UNITED STATES PATENT AND TRADEMARK OFFICE

APPLICATION NO.	FILING DATE	FIRST NAMED INVENTOR	ATTORNEY DOCKET NO.	CONFIRMATION NO.
10/826,166	04/16/2004	Phillip LeCompte	430165-092	8555

Office Action Summary

DETAILED ACTION

Figure 1 of Brennan et al. shows a double-chambered pale (10 with a wringer (15) located on one side of the pale.

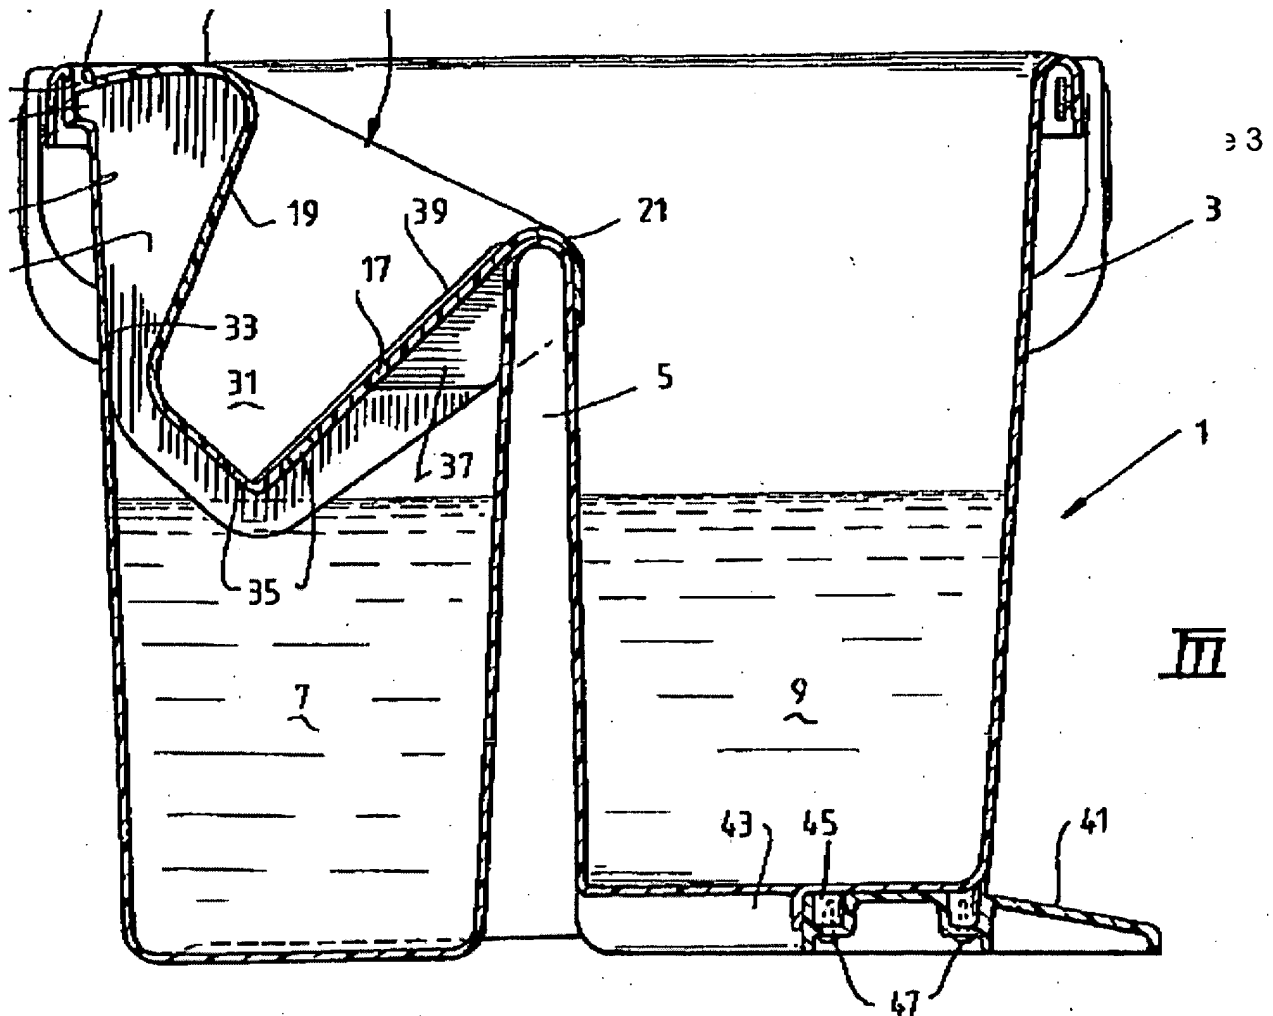
The wringer (15) comprises a support element (generally elements 23,25), having a wringer surface (generally element 19,35,17,21) which comprises a first portion consisting of wall (19) extending to drain holes (35) or optionally extending to wall (17). The wringer surface having a second portion which can be surface (17) extending to the curved portion (21) or optionally consisting of only curve portion (21).

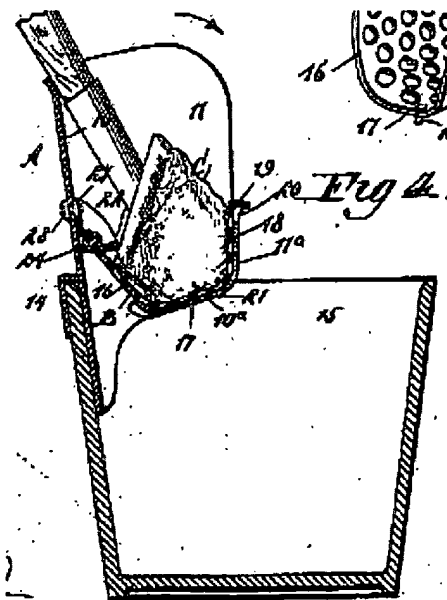
With respect to claim 18, the wringer (15) comprises a support channel which mates with the rim surface of the bucket, a support wall (generally element 25), a first surface (19) and a second surface (generally 31, 35, 17, and 21).

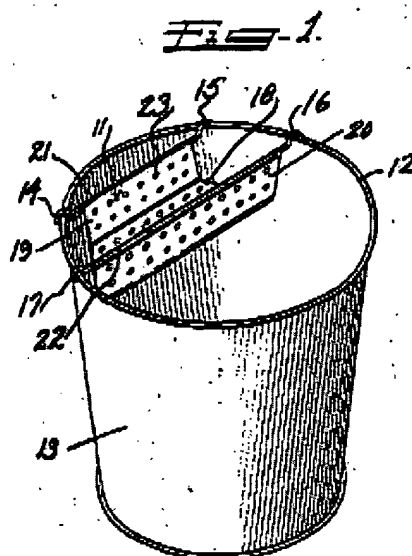
The Wolff patent discloses a wringer comprising an upper support wall (10) a second depending support walls (14) a first depending support wall (16), a wringer surface (17) and a second portion (18,19,20).
